Date of Issue: February 2019

Affected Publication: API Specification 7-1, *Specification for Rotary Drill Stem Elements*

Addendum 4

Figure 6—Lift Subs (Type D)

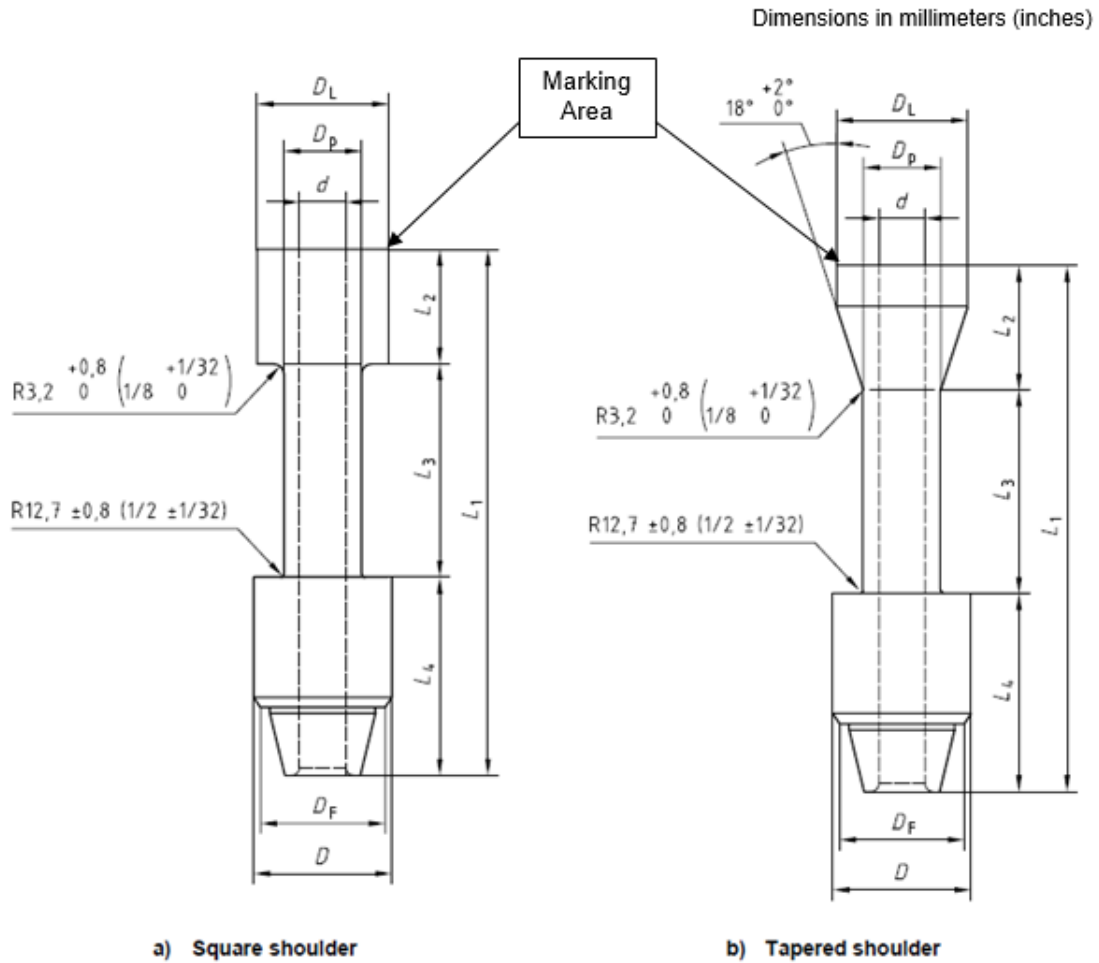
For subs of type D, the marking shall be on the top surface. The type D sub shall also be marked with the size of the recess diameter in characters at least 9.5 mm (³/₈ in) high.

Figure 6 shall be amended to the following:
